**Subject: Response to Portion of NRC Request for Additional Information Letter Nos. 80 and 126 Related to ESBWR Design Certification Application - Containment Systems - RAI Numbers 6.2-139, 14.3-235, and 14.3-236**

**Response to Portion of NRC Request for  
Additional Information Letter Nos. 80 and 126  
Related to ESBWR Design Certification Application  
Containment Systems**

**RAI Numbers 6.2-139, 14.3-235, and 14.3-236**

Figure 6.2-139-1. Schematic of PCCS with Vent Fan

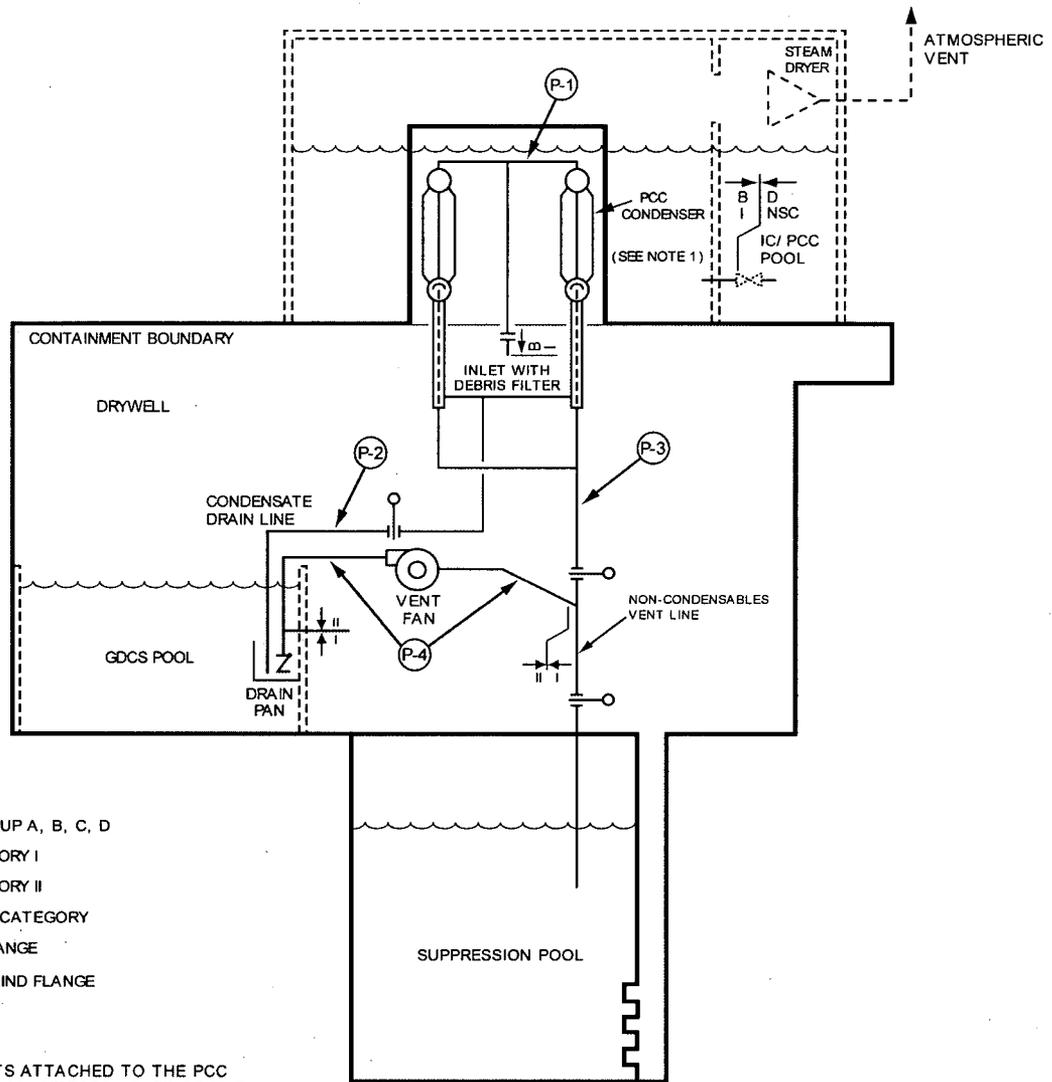
*Explain how the ESBWR design complies with 10 CFR 50, Appendix A, Criterion 38.*

*DCD, Tier 2, Revision 1, Section 6.2.2.3 states that "In conjunction with the pressure suppression containment (Subsection 6.2.1.1), the PCCS [passive containment cooling system] is designed to remove heat from the containment to comply with 10 CFR 50, Appendix A, Criterion 38." However, Criterion 38 requires that the containment heat removal system "safety function shall be to reduce rapidly, consistent with the functioning of other associated systems, the containment pressure and temperature following any loss-of-coolant accident and maintain them at acceptably low levels." The PCCS does not reduce rapidly the containment pressure and temperature as evident from the TRACG results presented in the DCD.*

Each of the six PCCS Vent Fans takes suction from a tee in the associated PCCS vent line, and discharges to the Gravity-Driven Cooling System (GDCCS) pool region. The PCCS Vent Fan discharge line includes submergence in the GDCCS pool and a passive check valve to ensure no back flow when the PCCS Vent Fan is not in operation. The PCCS Vent Fans are initiated by a manual operator action, and have the capability to be powered by backup power supplies if normal power should become unavailable. Figure 6.2-139-1 shows the schematic of one of the six PCCS Vent Fans.

Based on the results from the parametric case, an improvement in the pressure response can be attained if the PCCS Vent Fan discharge is relocated to the GDCS pool compartment (see Figure 6.2-139-1). This improvement is attributed to the relocation of NC gases to an area that is less accessible to the PCCS inlet. In the cases when the PCCS Vent Fans have a submerged discharge to the GDCS pool, the rated head value needs to increase to a value that accounts for the water hydrostatic head resistance and the fluid dynamic resistance due to a submergence of  $0.254 \text{ m}$  (10 in) of water in the GDCS pool. The rated head is expected to increase about  $1798 \text{ m}^2/\text{s}^2$  ( $19354 \text{ ft}^2/\text{s}^2$ ) for a total of about  $2400 \text{ m}^2/\text{s}^2$  ( $25833 \text{ ft}^2/\text{s}^2$ ). This rated head increase accounts for  $2488 \text{ Pa}/2.29 \text{ Kg}/\text{m}^3 = 1086 \text{ m}^2/\text{s}^2$  ( $11690 \text{ ft}^2/\text{s}^2$ ) due to the static water head, and about  $1798-1086 = 712 \text{ m}^2/\text{s}^2$  ( $7664 \text{ ft}^2/\text{s}^2$ ) for the dynamic resistance due to submergence. The PCCS Vent Fans submerged  $0.254 \text{ m}$  (10 in) and discharging to the GDCS pool at the rated head discussed above under  $299 \text{ kPa}$  ( $43.4 \text{ psia}$ ) of pressure and  $403^\circ\text{K}$  ( $130^\circ\text{C}$ ) temperature will be able to supply a minimum volumetric flow rate of about  $0.145 \text{ m}^3/\text{s}$  (307 cfm) and a fluid density ( $\rho$ ) of  $2.29 \text{ Kg}/\text{m}^3$  ( $0.143 \text{ lb}/\text{ft}^3$ ).

The use of submergence for the PCCS Vent Fan outlet discharge to the GDCS pool is a measure to ensure proper functioning of PCCS, and to prevent direct flow from DW to the suppression pool through the vent line when the PCCS Vent Fans are not in operation. Furthermore, to prevent the possibility of any liquid back flow that may occur during the blowdown phase of the event or any other time, a passive check valve is installed at the discharge side of the PCCS Vent Fan to ensure that no back flow occurs.

From the above discussions and calculated results, GEH opted to implement the PCCS Vent Fans discharging to the GDCS pool region, including submergence and passive check valves to ensure no back flow when the PCCS Vent Fans are not in operation.

Figure 2.15.4-1. Passive Containment Cooling System Schematic

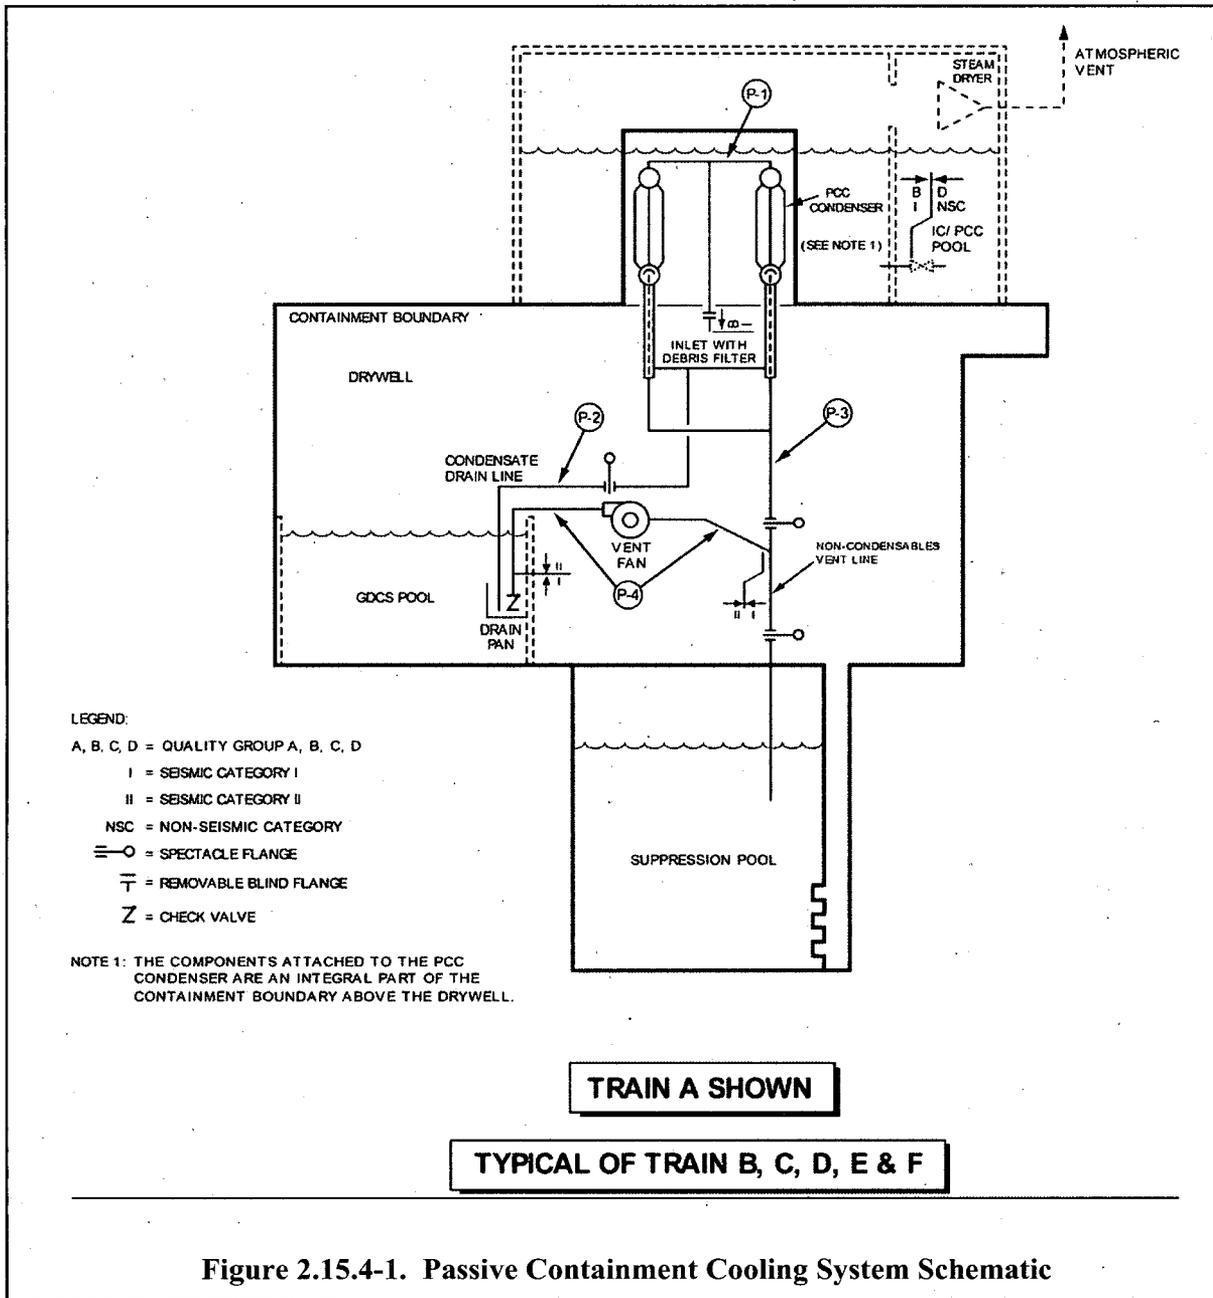
*DCD Tier 1, Revision 4, Section 2.15.4, states that the passive containment cooling system "is entirely passive, with no moving parts." However, GEH has informed the staff that the PCCS is to be supplemented with a drywell gas recirculation system (DGRS) after 72 hours following a LOCA. When the DGRS system design is submitted for staff review, provide an update to DCD Tier 1 to indicate that the DGRS is an active system.*

DCD Tier 1, Subsection 2.15.4, Table 2.15.4-1, Table 2.15.4-2, and Figure 2.15.4-1 will be revised as shown in the attached markup.

GEH agrees. See the response above to RAI 6.2-139 for DCD Tier 1 markups addressing the addition of the Passive Containment Cooling System (PCCS) Vent Fans and associated components.
